Access Compliance Report

Public Rights-of-Way

Intersection ID: 4530	Main Street: BROOKSHIRE_BV	Cross Street: MT_HOLLY-HUNTERSVILLE_RD	Location: SW
ADA ID: 1CA7765B38A9	Ramp Type: BlendTrans1	Initial Pass/Fail: Fail	Overall Compliance: No
Severity Score: 8.75			
Codes/Mitigation Info/Possible Solution		Field Measurements/Component Compliance

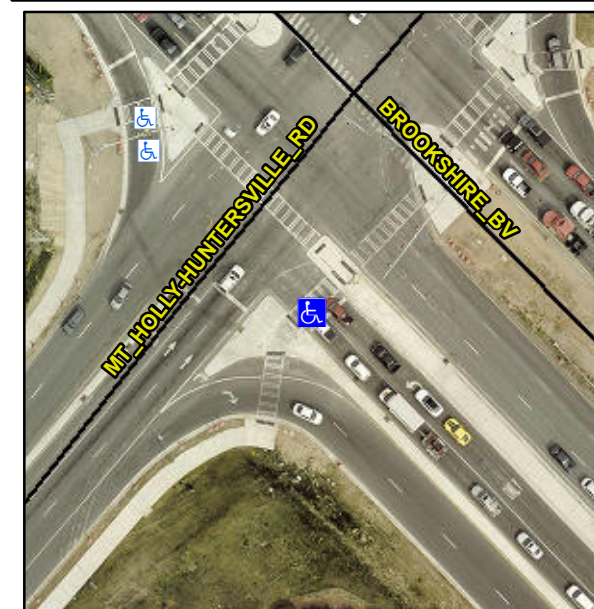
R304.5.1

Remove & Replace Curb Ramp With Two New Directional Ramps or Equivalent.
